# UNITED STATES PATENT AND TRADEMARK OFFICE

APPLICATION NO.	FILING DATE	FIRST NAMED INVENTOR	ATTORNEY DOCKET NO.	CONFIRMATION NO.
10/604,101	06/26/2003	Dirk Schneider	703094	1100
30008 7590 07/20/2007 GUDRUN E. HUCKETT DRAUDT SCHUBERTSTR. 15A WUPPERTAL, 42289 GERMANY				
			EXAMINER REDMAN, JERRY E	
			ART UNIT 3634	PAPER NUMBER
			MAIL DATE 07/20/2007	DELIVERY MODE PAPER

## Office Action Summary

## REPLACEMENT SHEET

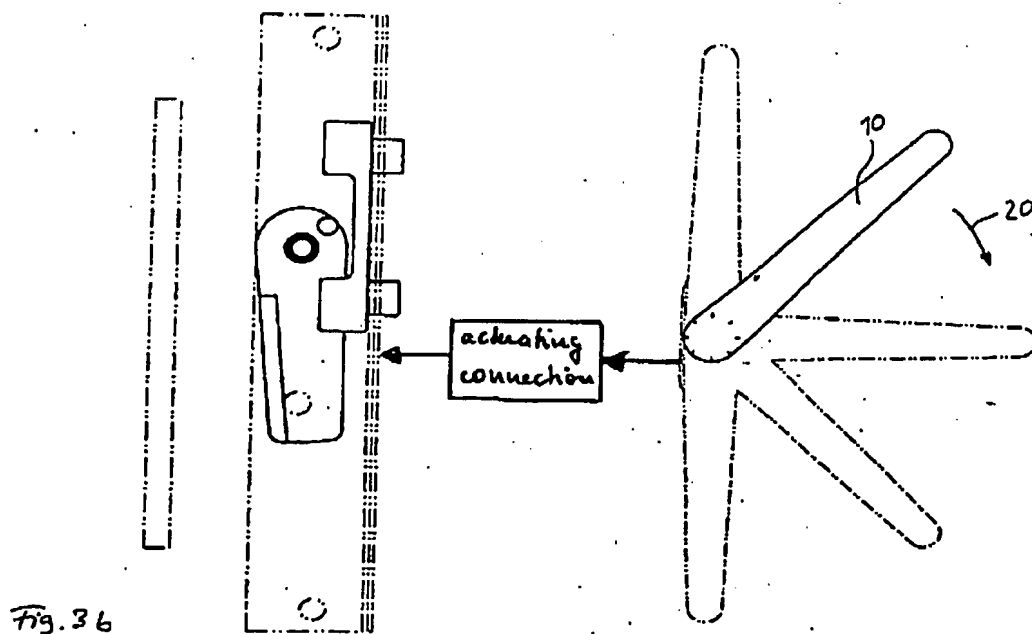
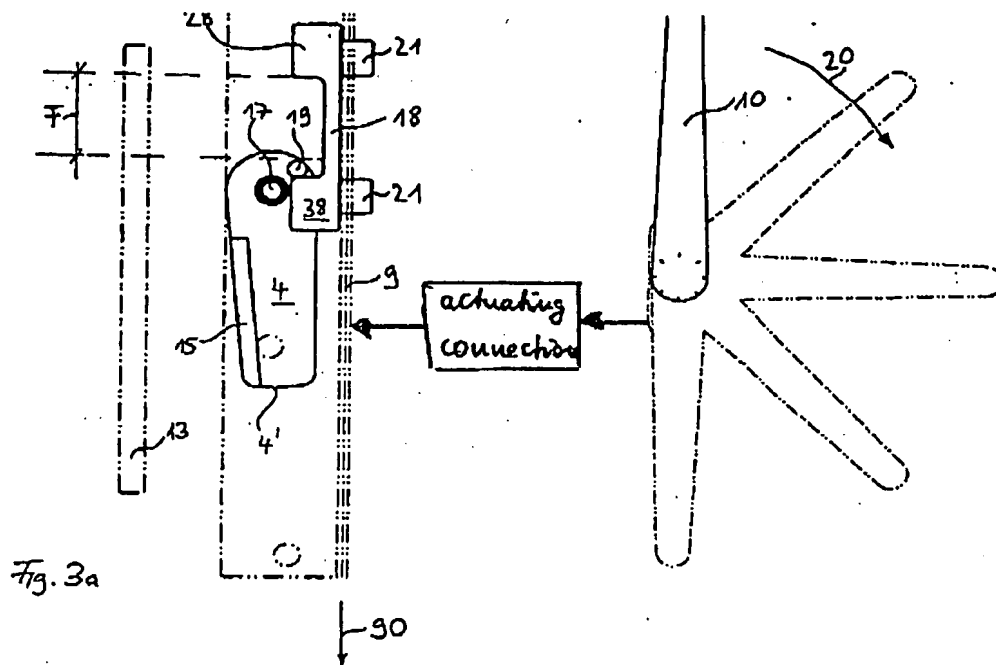
The applicant's proposed changes to the drawings are not approved by the Examiner. The drawings show a vague actuation of how the device works which fails to overcome the rejections below.

The drawings are objected to under 37 CFR 1.83(a). The drawings must show every feature of the invention specified in the claims. Therefore, the handle being connected to the push rod as recited in claim 1, line 7, must be shown or the feature(s) canceled from the claim(s). No new matter should be entered.

Claims 1-17 are rejected under 35 U.S.C. 112, first paragraph, as failing to comply with the enablement requirement. The claim(s) contains subject matter, which was not described in the specification in such a way as to enable one skilled in the art to which it pertains, or with which it is most nearly connected, to make and/or use the invention. How does the handle (10) interconnect with the push rod (9)?

NOT APPROVED  
7/19/2007

Corrected drawing sheets in compliance with 37 CFR 1.121(d) are required in reply to the Office action to avoid abandonment of the application. Any amended replacement drawing sheet should include all of the figures appearing on the immediate prior version of the sheet, even if only one figure is being amended. The figure or figure number of an amended drawing should not be labeled as "amended." If a drawing figure is to be canceled, the appropriate figure must be removed from the replacement sheet, and where necessary, the remaining figures must be renumbered and appropriate changes made to the brief description of the several views of the drawings for
